FIELD OBSERVATION – SECOND FLOOR CEILING REPORT 07-11-2016

AEI Project Number and Name: 14018 – The Park Danforth

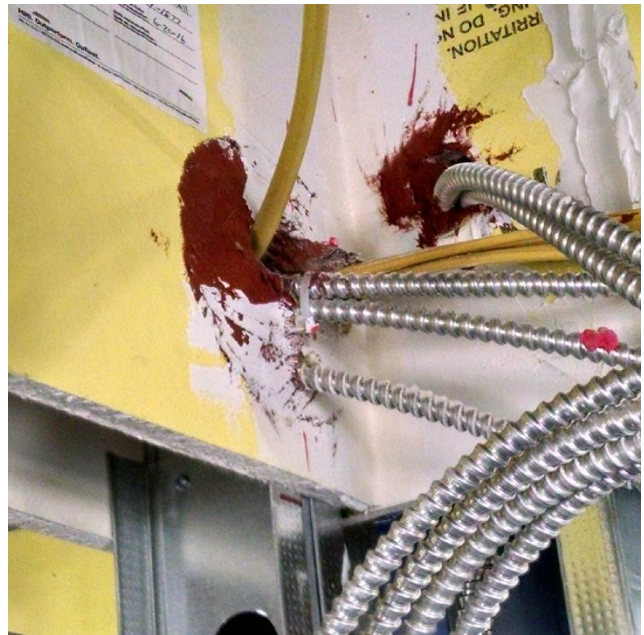
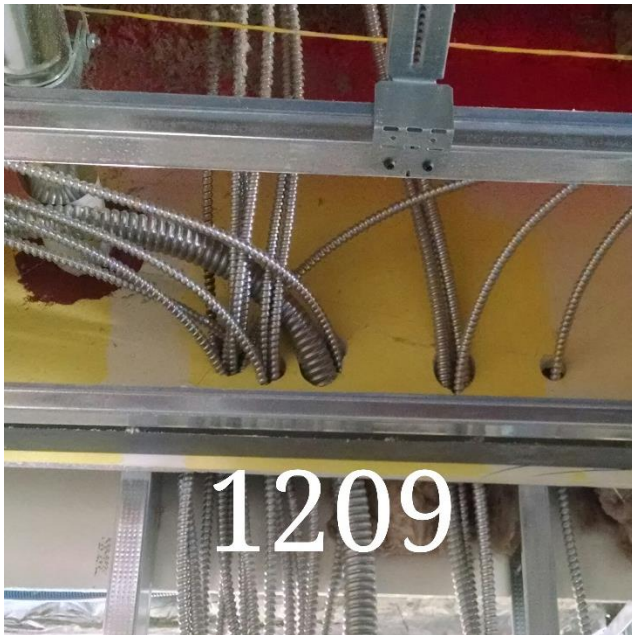
1. All temporary wiring must be completely removed prior to project close out. See below for an example.

2. Support wiring so that it does not rest on hat channel. See below.

3. Fire caulk all penetrations through rated assemblies; re-apply when temporary wiring is removed. See below.

4. In areas where drywall is installed- particularly at ceilings- large gaps exist between the face of outlet boxes and the face of the drywall. Ensure any gaps that exist are code-compliant or take steps to eliminate the gaps. See below.
